SS 725-WST 2022 Power Steering Cap Contact with Hood Strap

49X & 47X vehicles equipped with 4qt power steering reservoir

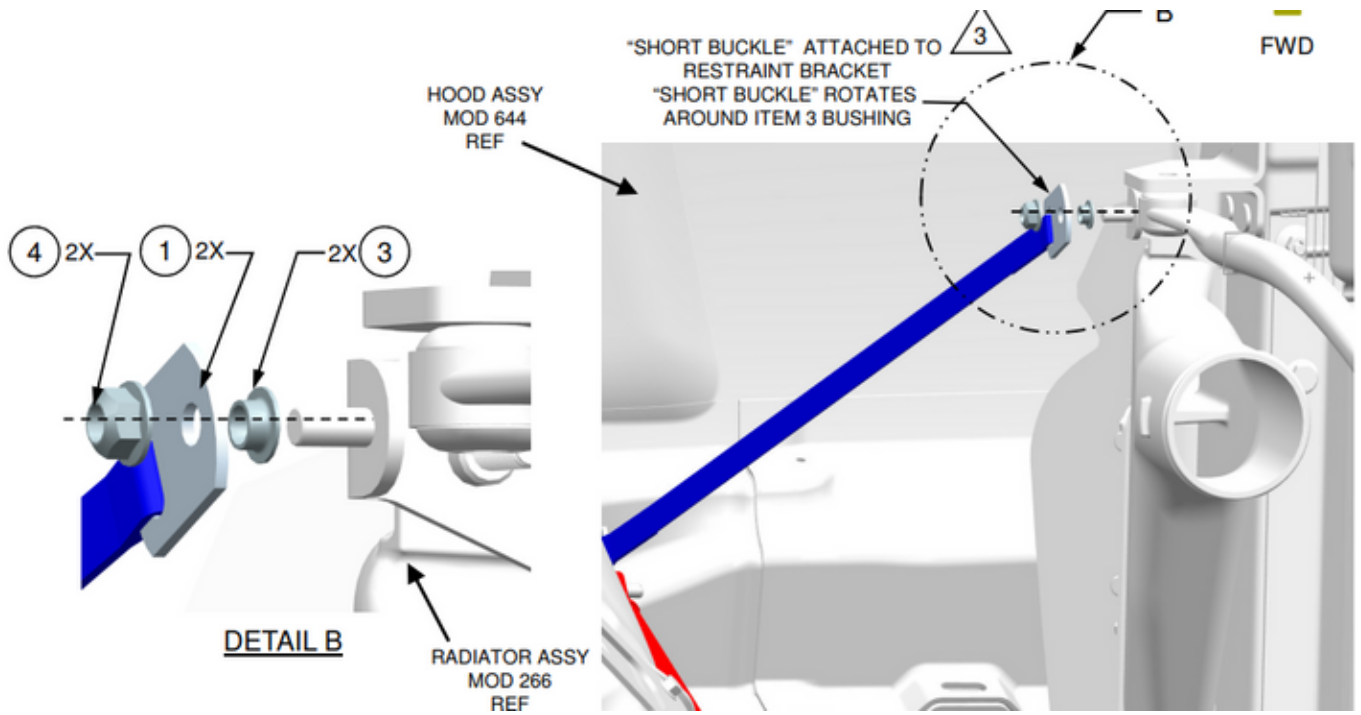
Power steering cap may become loose/detached or missing.

Under certain conditions the drivers side hood restraint strap, which is attached to the radiator and hood, may become lodged behind the power steering cap. When opening the hood, the hood restraint strap may pull on the power steering cap resulting in the cap coming off of the reservoir.

Removal of compression ring bushing from the radiator side of the hood restraint strap installation and torque mounting nuts with restraint strap buckle facing forward per information below:

1. Open hood
2. Remove compression ring bushing (item 3 below)
3. Reinstall strap to radiator stud, leave nut loose
4. Allow hood to rest on restraint straps with hood in full open position and assure the buckle is facing forward
5. Torque nut to 24 ft/lbs
